Considerations for Future Modeling of a Deep Decarbonization and Electrification Scenario

Comments regarding Duke Energy Indiana's
2024 Integrated Resource Plan

Prepared for Energy Matters Community Coalition

February 13, 2025

Figure 2. New Energy Resources in DDRE portfolio

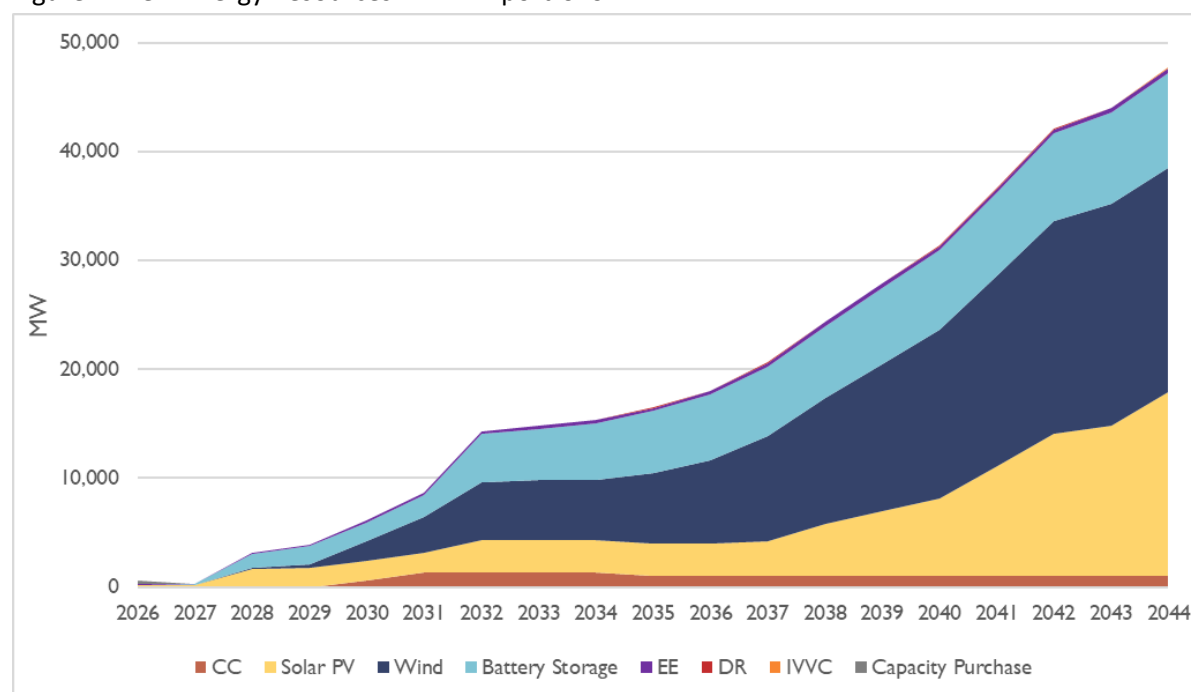
Duke’s DDRE portfolio includes unprecedented levels of investment in clean energy resources. Also included are energy efficiency and demand response. Notably, Duke has not included distributed energy resources (DERs) beyond energy efficiency and demand response in its DDRE scenario, although much of

the renewable energy shown in Figure 2 below could potentially be provided by DERs such as customer-sited solar PV and wind.

FIGURE 5. DUKE’S POLICY SCENARIOS

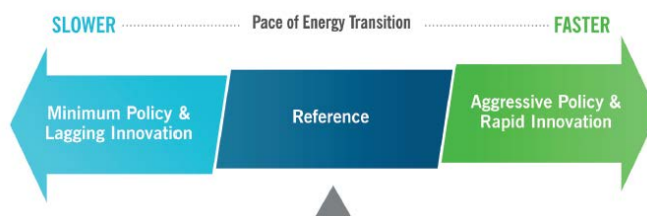
Duke’s consideration of an aggressive GHG policy scenario provides valuable information about the resources that would be selected in a future with strong GHG regulation. However, we are concerned that Duke has not incorporated any GHG mitigation in its long-term plan preferred portfolio. While a few scenarios in the IRP consider GHG policy, Duke’s preferred portfolio does not appear to make any effort to reduce GHG pollution in response to climate risk or GHG regulatory risk.
